\*\*\*\*\*  
\* ALL SERVICE QUESTIONS FROM EUROPE, MIDDLE EAST, \*  
\* AND AFRICA SHOULD BE ADDRESSED TO THE EUROPEAN \*  
\* MARKETING CENTER SERVICE GROUP IN THE NETHERLANDS. \*  
\*\*\*\*\*  
TEKTRONIX INTERNAL USE ONLY

June 27, 1980  
Issue 10-13

## 7844/R, R7903 AND 7904 TRANSFORMER REPLACEMENT

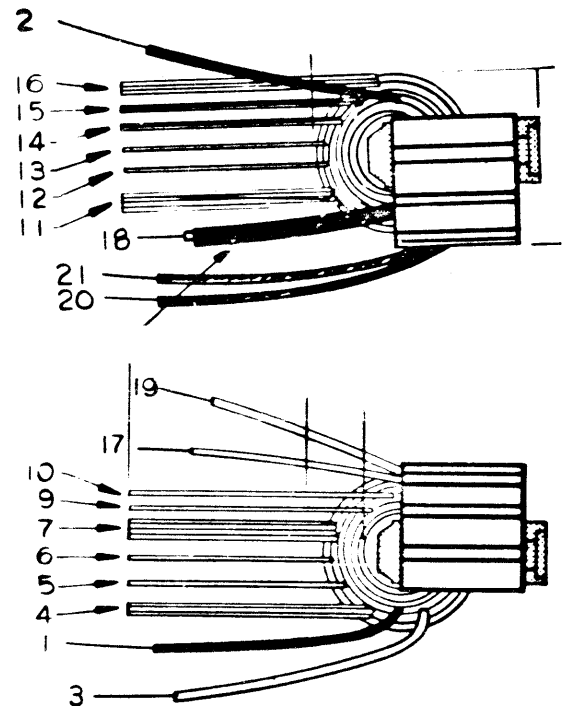
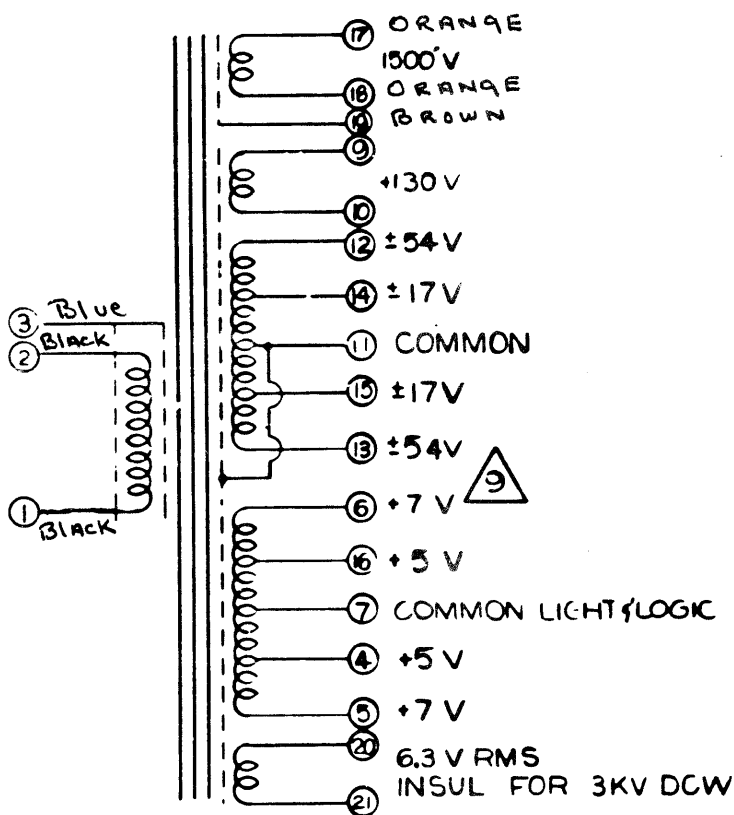
The power transformer, P/N 120-0742-00, previously used in the above instruments, has been replaced by P/N 120-1250-00. The only change is that on the +5 volt light winding, instead of increasing wire size, an extra wire was added. These wires are terminals #4 and #16, and are now 3 large tinned copper wires. It is difficult to connect these wires, as the holes are small, but with care it can be done. Below are drawings which should help in wiring.

067-0655-00, SIGNAL PICK-OFF CABLE REPLACEMENT

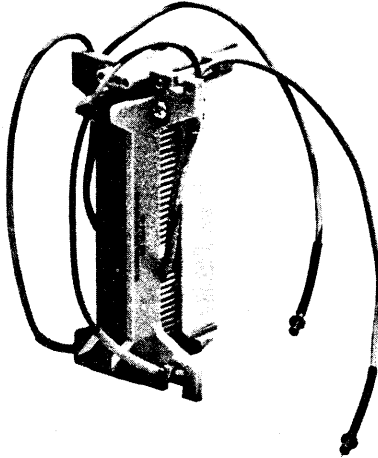
After a period of time the coax cables and connectors on this fixture can become intermittent, or may have broken loose from the connector. The cables are very critical as far as their length is concerned. Do not replace them with just any coax. A cable replacement set is available and contains all four cables. Order P/N 198-2788-00.

## 1460/BURST GAIN "BOUNCE" WITH SOUND IN SYNC

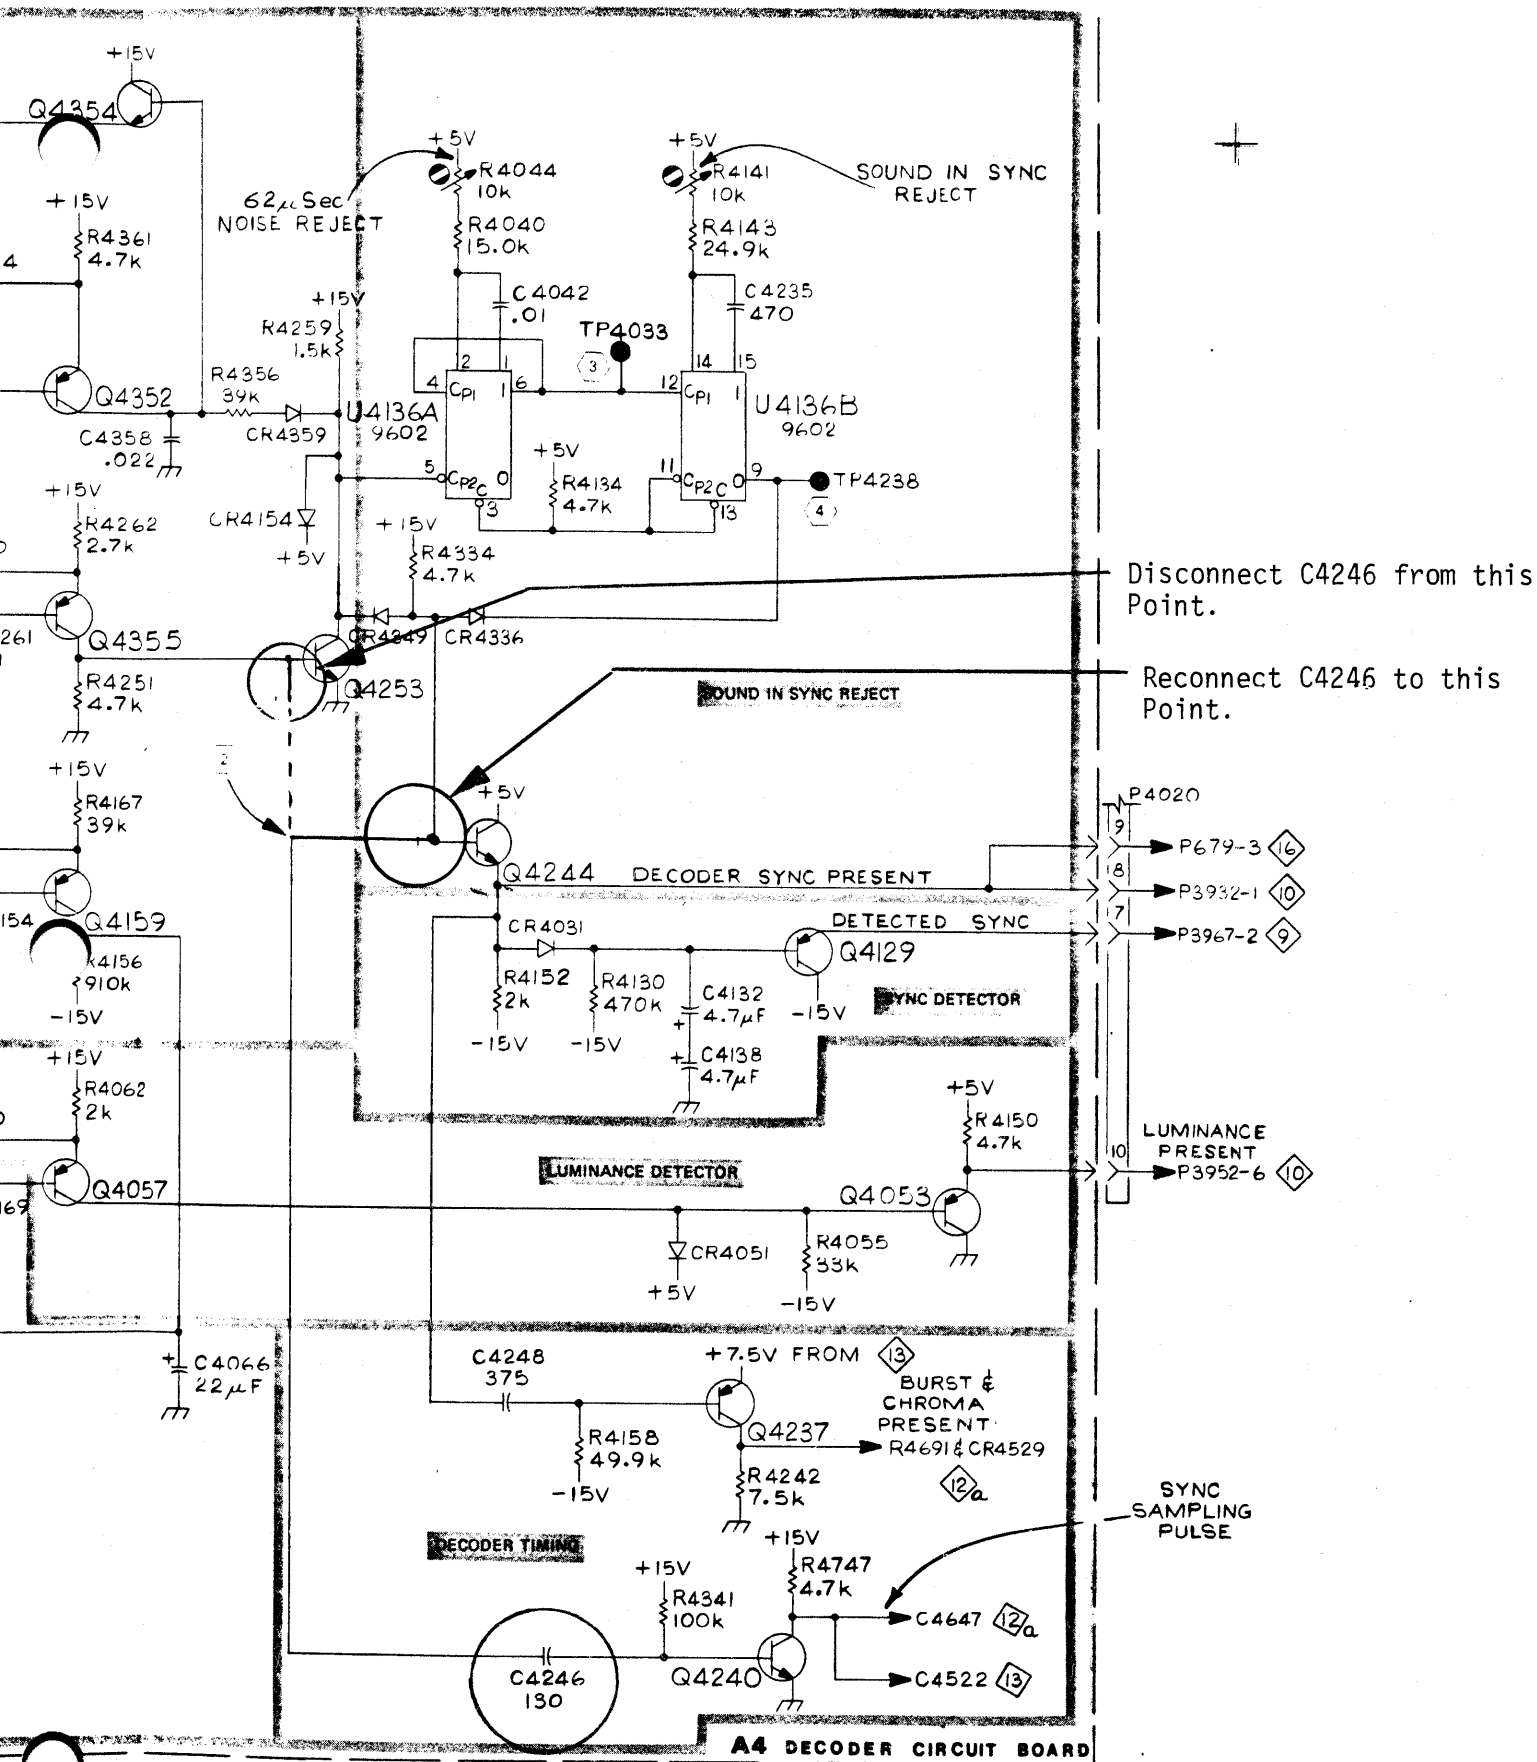
1460 instruments used in Sound-in-Sync applications may exhibit Burst and/or Chroma gain "bounce". The sync sampling pulse for decoders (U4651 A & B) has sound-in-sync (S-I-S) present. This causes faulty clamping at TP4351 and TP4721. The end result is varying burst and chroma gain on the output. To correct this malfunction, lift the end of C4346 (A4 decoder circuit board) connected to the collector of Q4253. Reconnect this lead to the base of Q4244. Since the signal present on the base of Q4244 comes from the S-I-S reject circuitry (U4136 A & B), it does not have S-I-S present.

The chroma gate pulse at P4699-1 (Schematic 12a ) is too wide and allows the sync pulse at the end of the VIT's line to pass. The S-I-S on this sync pulse is decoded by U44568 and U4466 and is passed as a DC level shift by the sync-sampling pulse. To correct this problem, the chroma gate pulse is shortened by adding an R-C network to U3352. On the back side of board cut the run going to pin 1 of U3352 (see drawing). Solder one end of 2.7K ohm resistor (315-0272-00) to the end of R3332 connected to U3342 pin 4 (+5v). Solder one end of another 2.7 Kohm resistor (315-0272-00) to ground (see parts locator diagram included). Solder one end of a 470pf capacitor (283-0197-00) pin 3 of U3352. Solder the other end of the capacitor and both free ends of the two resistors to pin 1 of U3352. This modification should be installed as units come in for service.

Illustration 1.

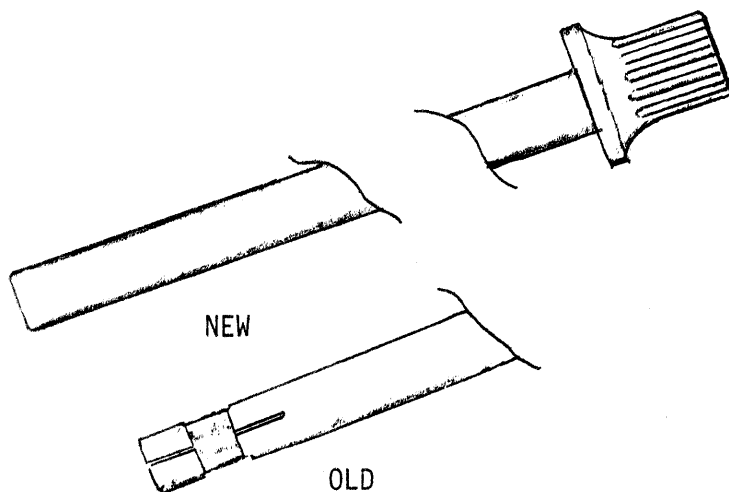
To reduce binding of shafts for position controls, CRT controls, etc., the molded knobs with shafts have been redesigned. With the new shaft, the controls will rotate freely and will have a better "feel". The illustration below shows the physical difference between the two shafts. Though the difference is minor, the new shafts will work much better. The new P/N's are a direct replacement.

#### 4631/32/33A/34: CLUTCH AND CONTROL BOARD MODIFICATIONS #37349, 40065 AND 40750

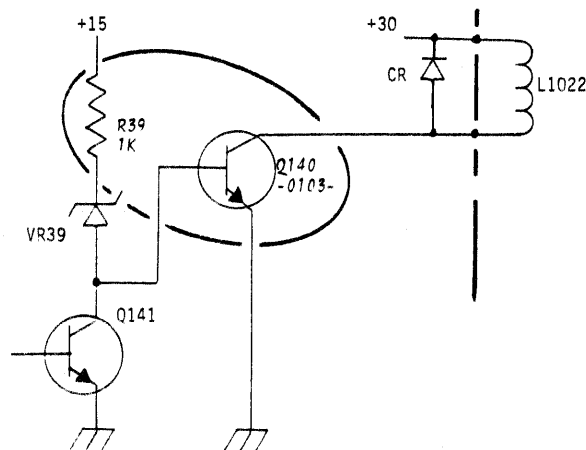
To correct this, MOD 37349 has been implemented. The internal resistance of the coils in both the 105-0519-00 and 105-0520-00 has been increased from near 90 ohms to about 145 ohms. The new part numbers are 105-0519-02 for the drive roller clutch (L1020) and 105-0520-01 for the cutter clutch (L1022).

In addition, R1 on the 4633A control board had been changed from 47 $\Omega$  to 27 $\Omega$ . This increased the voltage applied across the drive roller solenoid, L1020. It also rolled the control board part number from 670-4599-06 to 670-4599-07. It was found that low-line conditions could still cause the drive roller clutch flapper to fail to pull in.

To solve this difficulty, modification 40750 removes R1 and substitutes a shorting strap. The control board now changes level once again.
